Project	IEEE 802.16 Broadband Wireless Access Working Group < http://ieee802.org/16 >	
Title	Enhanced contention based association	
Date Submitted	2005-03-09	
Source(s)	Kiseon Ryu, Aeran Youn, Beomjoon Kim LG Electronics 533,Hogye-1dong,Dongan-gu, Anyang-shi,Kyongki-do,Korea	Voice: 82-31-450-4387 Fax: 82-31-450-7912 [mailto:ksryu@lge.com] [mailto:aryoun@lge.com] [mailto:beom@lge.com]
Re:	The document supports a comment at Sponsor Ballot on 802.16e/D6 document	
Abstract	The document suggests text changes to enhance contention based association.	
Purpose	The document is for consideration during Sponsor Ballot comments resolution	
Notice	This document has been prepared to assist IEEE 802.16. It is offered as a basis for discussion and is not binding on the contributing individual(s) or organization(s). The material in this document is subject to change in form and content after further study. The contributor(s) reserve(s) the right to add, amend or withdraw material contained herein.

Enhanced contention based association

Kiseon Ryu, Aeran Youn, Beomjoon Kim
LG Electronics

IEEE C802.16e-05/172

Figure. Example of contention based association

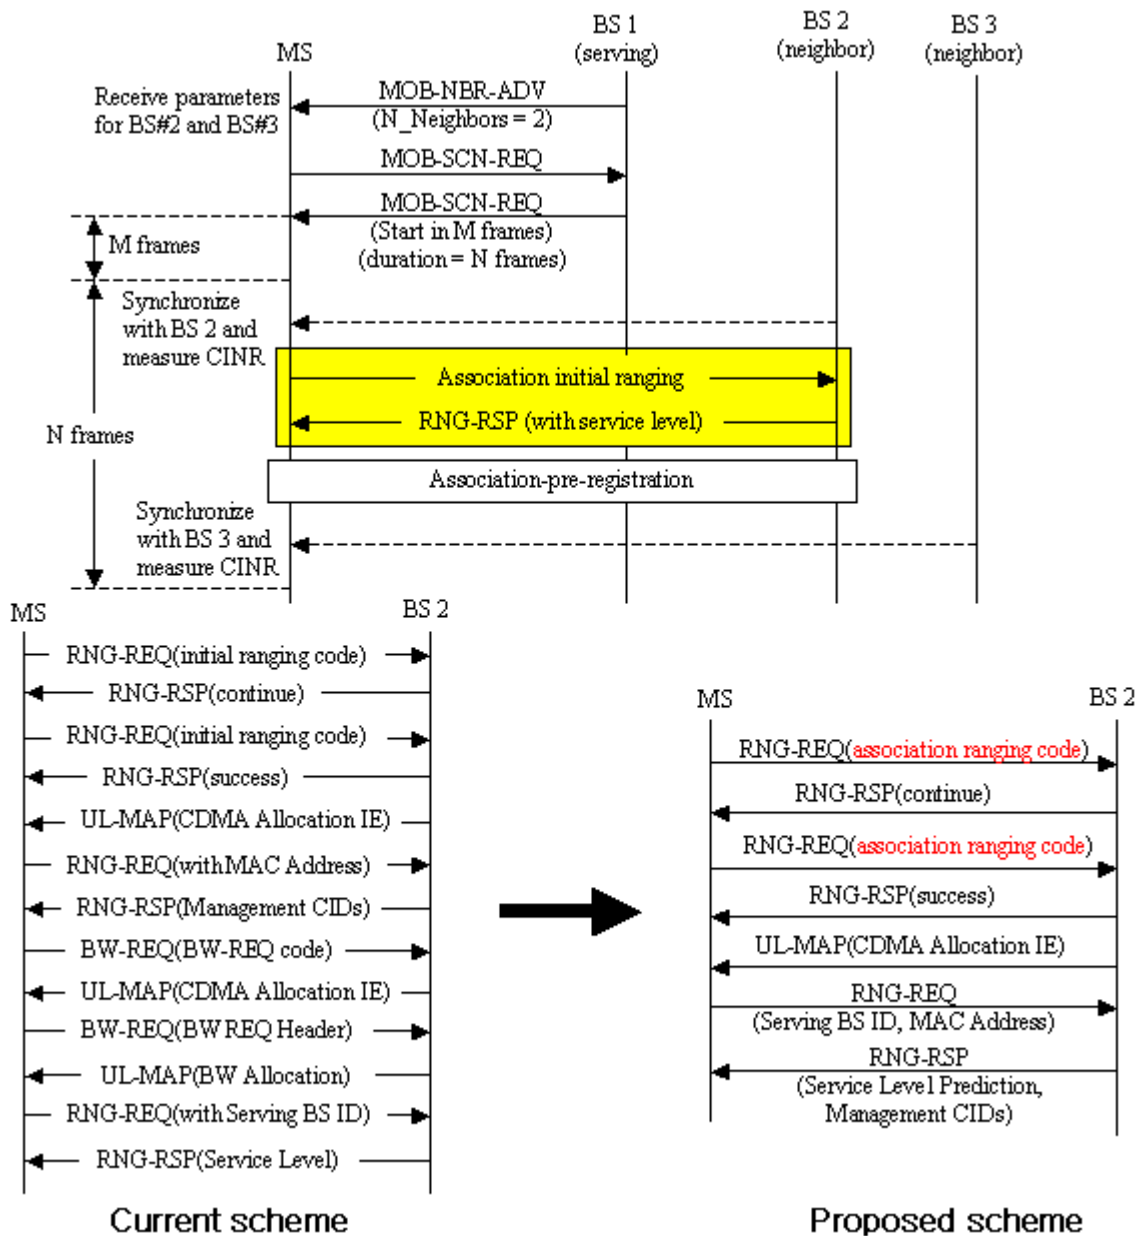
MS transmits initial ranging request for association and network entry by using initial ranging code in the UL initial ranging interval. Therefore, the BS receiving initial ranging request from the MS can not tell whether the MS is attempting network entry or association, until it receives RNG-REQ including Serving BS ID TLV.

This causes all MSs to perform the procedure for Basic/Primary management CID allocation, UL-BW Request to transmit Serving BS ID TLV, and so on. The BS can determine MSs' Service Level Prediction only after receiving Serving BS ID for the MS. If Service Level Prediction is 0 or 1, the procedure for allocation of management CIDs and bandwidth request to transmit Serving BS ID was unnecessary and caused delay for association.

If a BS differentiates initial ranging for association from network entry, it can allocate appropriate UL BW for its own purpose to the MS. This can be achieved by using ranging codes assigned only for association. Using distinctive ranging code for association makes the association procedure shorter and faster than using initial ranging code.

So, we propose Association CDMA Ranging Code to indicate initial ranging request for association.
